NUCLEAR REACTOR LABORATORY
AN INTERDEPARTMENTAL CENTER OF
MASSACHUSETTS INSTITUTE OF TECHNOLOGY

Re: Response to Request for Additional Information (TAC No. MA6134), Docket
No. 50-20, License No. R-37.

Response to TAC No. MA6134

Overexposure During Mechanical Shutter Failure

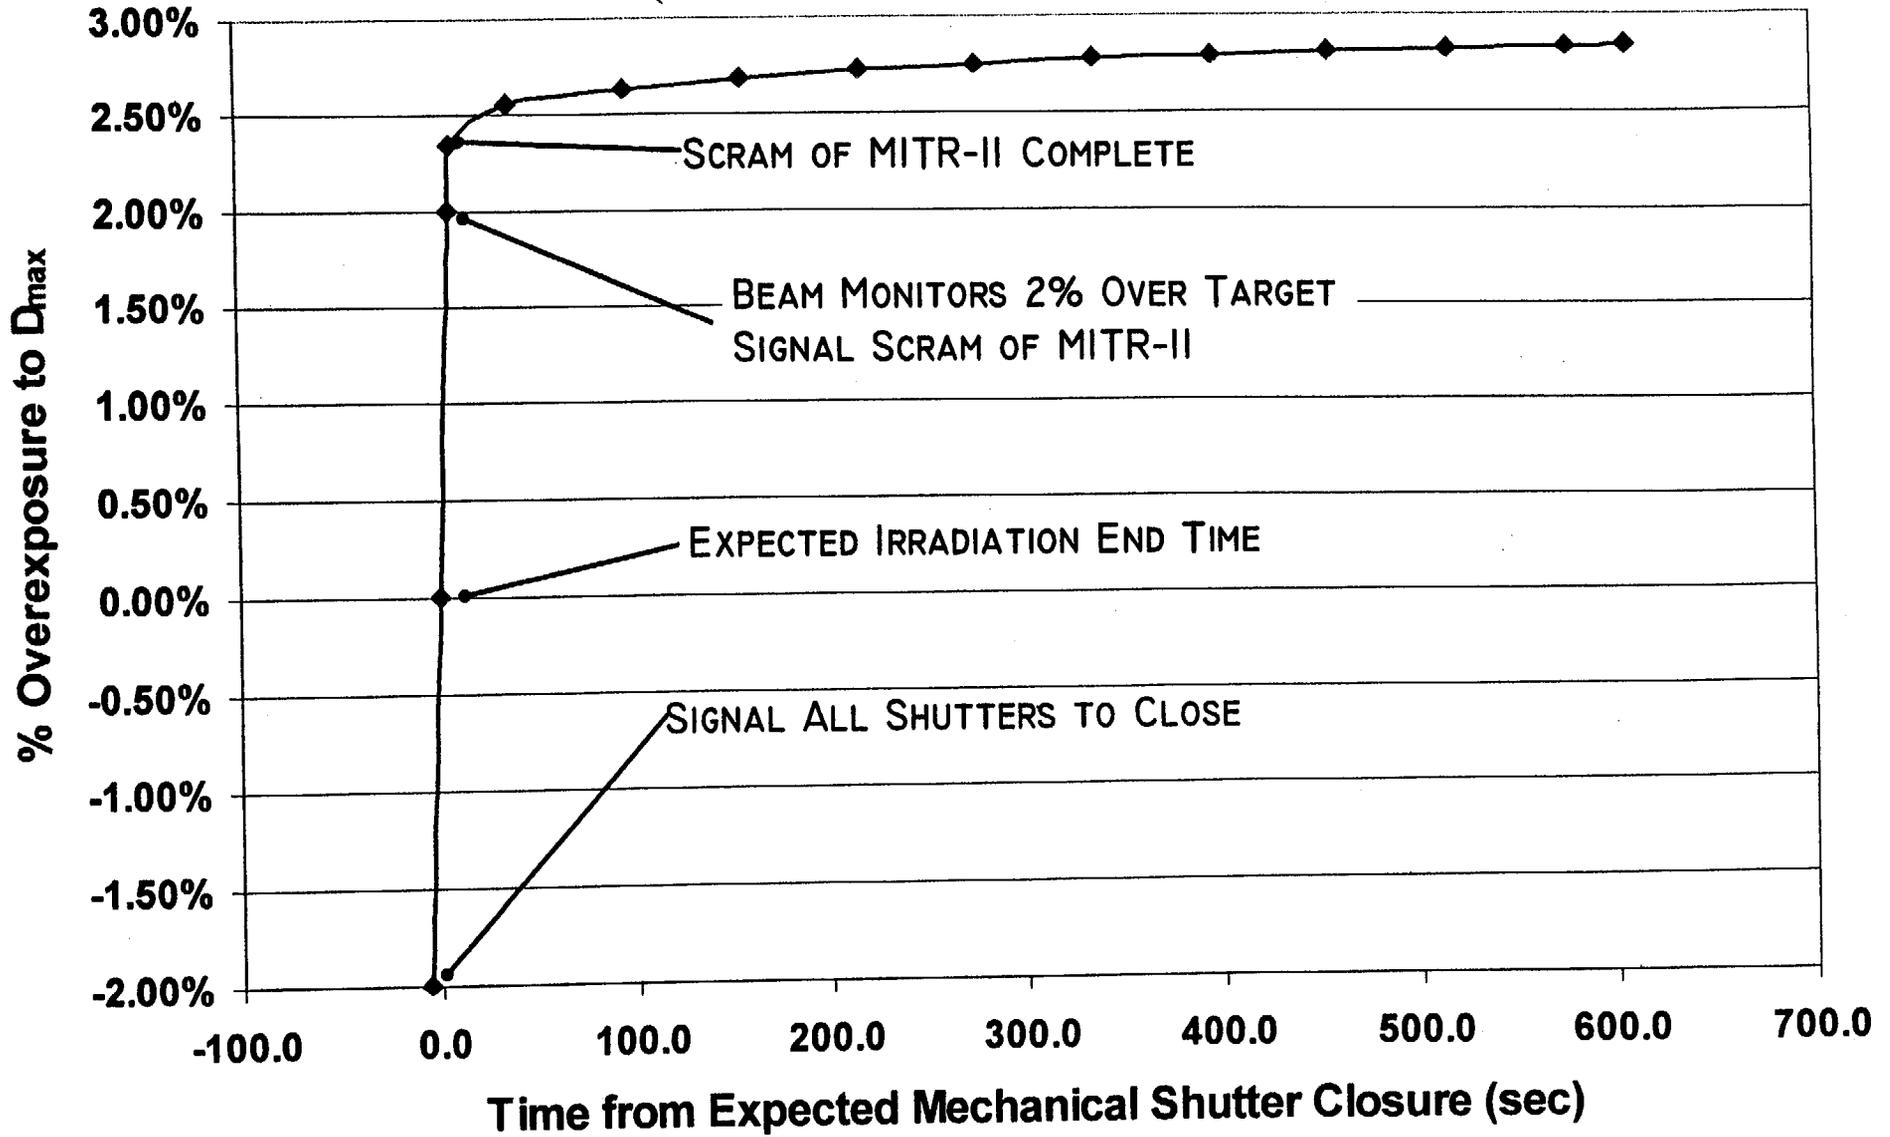
- This worst case scenario leads to a maximum patient overexposure of 2.7%
- In this worst case scenario, the mechanical shutter fails such that it cannot be closed
- The Beam Monitoring System (BMS) accumulates 2% excess counts (6 seconds for a 5 minute irradiation) and then automatically scrams the MITR, reducing the dose rate by two orders of magnitude. The BMS has redundant, independent circuits and is backed up by separate uninterruptible power supplies.
- The water shutter closes in 100 seconds which provides another factor of 10 in gamma attenuation. Delayed neutrons have also decayed to negligible levels during this time. At this point the dose rate in the direct beam is ~ 0.019 Eq. Rad/min.
- Once the reactor has scrammed and the water shutter has filled, the patient could remain in the room up to $0.1 * 1200 / 0.019 = 6300$ minutes before approaching a 10% overexposure.

FRONT VIEW OF MECHANICAL SHUTTER

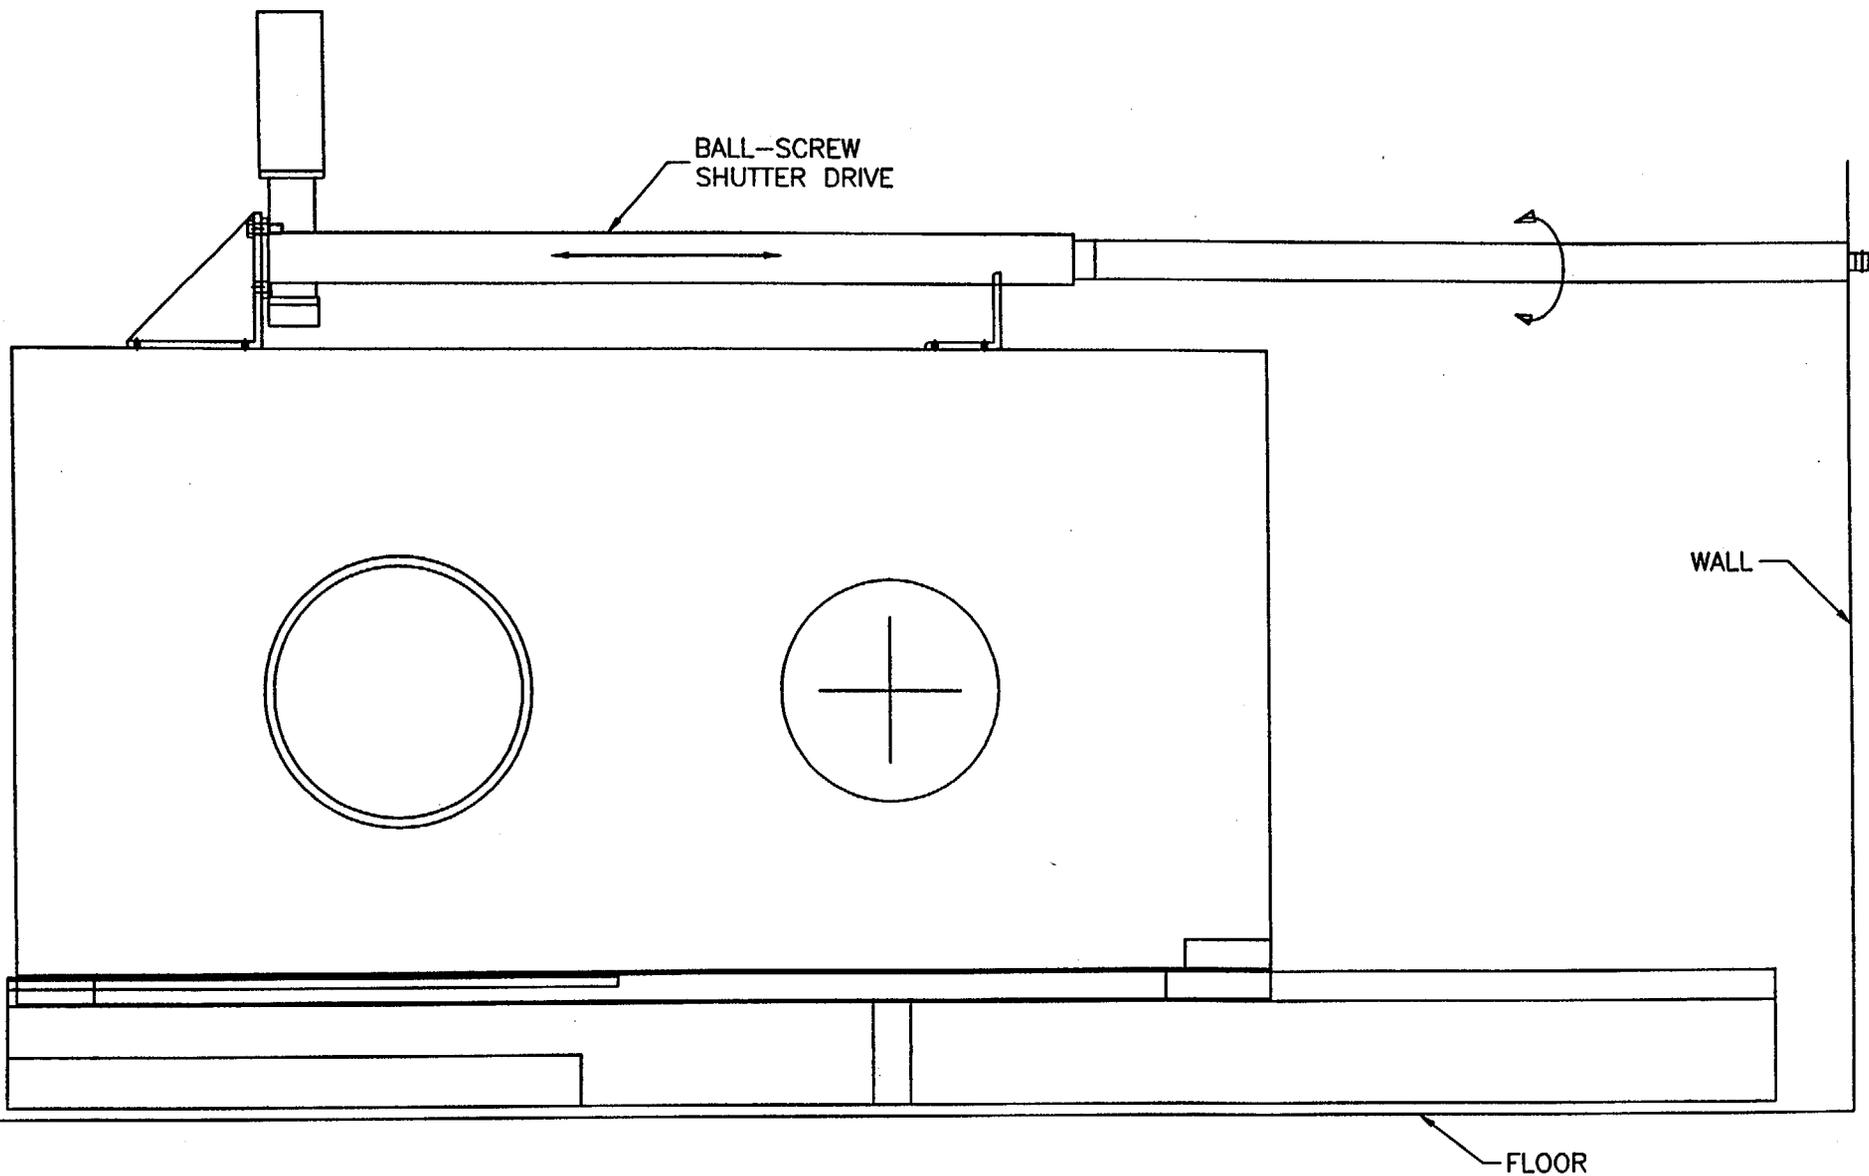
14. Drawings of the components listed in TAC Question Nos. 14(a) - 14(f) are included as an attachment to this response. Please refer to Appendix B. There are no common components to the two shutters that control beam delivery with the exception of electrical power. As described in our response to TAC Questions No. 1, 2, and 11, fail-safe provisions exist to ensure both patient and staff safety in the event of loss of electrical power. The staff would become aware of a loss of motive power to a shutter by the occurrence of the associated fail-safe action (shutter-closure or reactor scram). Failure of a shutter for other reasons (e.g., foreign material precluding movement) would be detected by the redundant beam monitor system which would generate an automatic reactor scram. The indicator lights would also show a failure when shutter closure was attempted and did not give the desired result. If electrical power were lost to the facility as a whole, the activation of the emergency power system would be a further indication.
